With reference to case number ER16-010, I would like to pose concerns and questions for inclusion in the CEQA/EIR scoping process.

With respect to the proposed tennis stadium:

Diagram showing proximity of proposed tennis stadium to nearby homes protected by the in-force noise injunction is below.

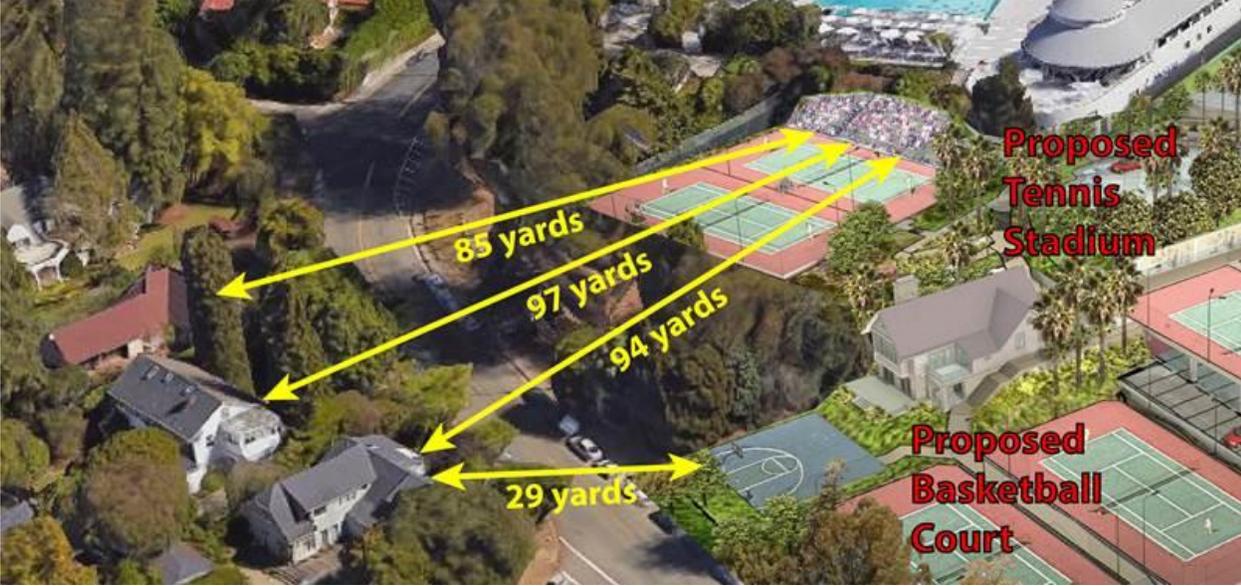
2. In light of this, how can the planned tennis stadium, with elevated seating funneling sound directly into neighboring homes from a distance of less than 100 yards be permitted? (See diagram of distances to homes, attached.)

3. For the same reason, how can construction of a basketball court less than 30 yards from neighboring homes be permitted?
4. Developers claim that the capacity of the tennis stadium is only 100 persons, however examination of their drawing shows more than 2400 square feet of projected area devoted to bleacher benches. This would be more than enough bleacher capacity for as many as 400 spectators. How do the developers explain this discrepancy between their stated and their architectural plans? How is the proposed bleacher capacity being measured? How is the stadium capacity being limited?
